## TECHNICAL MEMORANDUM

Subject: Z.C. Case No. 19-16: MCF WALP Phase 1, LLC – 1200 5<sup>th</sup> Street, NW PUD  
Responses to Parking Issues Raised at Zoning Commission Hearing

Figure 1: Park Right DC Results

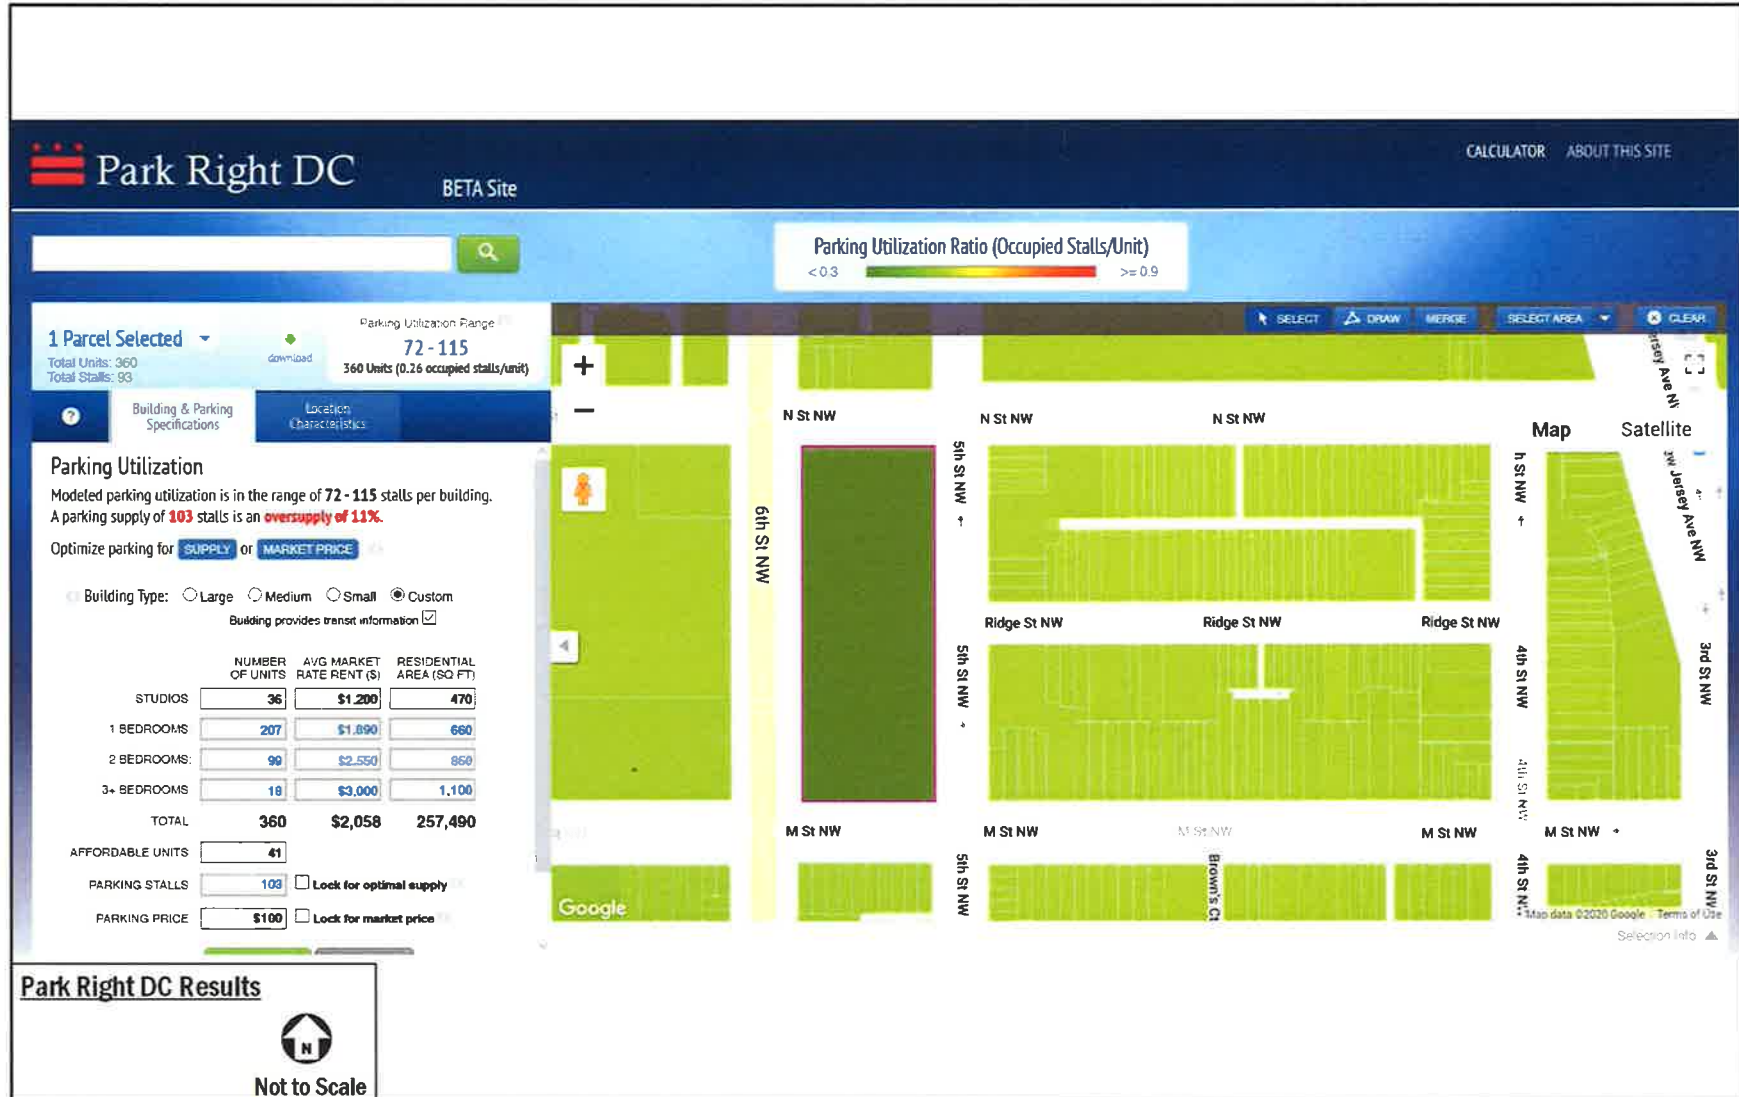
This memorandum presents responses to two parking related issues raised at the January 16, 2020 Zoning Commissions Hearing for the MCF WALP Phase 1, LLC (ZC Case #19-16) Project, located at 1200 5<sup>th</sup> Street NW. During the hearing issues were raised regarding the Project's parking supply and demand, and the Commission requested additional information on Residential Permit Parking (RPP) designations. This memorandum provides responses to both items.

The Project’s parking utilization based on the Park Right DC tool is shown in Figure 1. The projected utilization of 72-115 spaces falls within the 103 proposed spaces for the Project. It should also be noted that after the Project is completed, 47 on-street parking spaces will exist on the streets that bound the Project. Thus, if the parking demand for the Project ends up at the higher end of Park Right DC’s range and exceeds 103, the on-street spaces immediately adjacent to the Project can easily accommodate the additional demand.

Because the Project meets both the Zoning minimums and Park Right DC’s estimated parking demand, this memorandum concludes that the amount of parking provided in the Project is appropriate, and meets the goal of providing enough parking to accommodate demand while not encouraging driving as a mode.
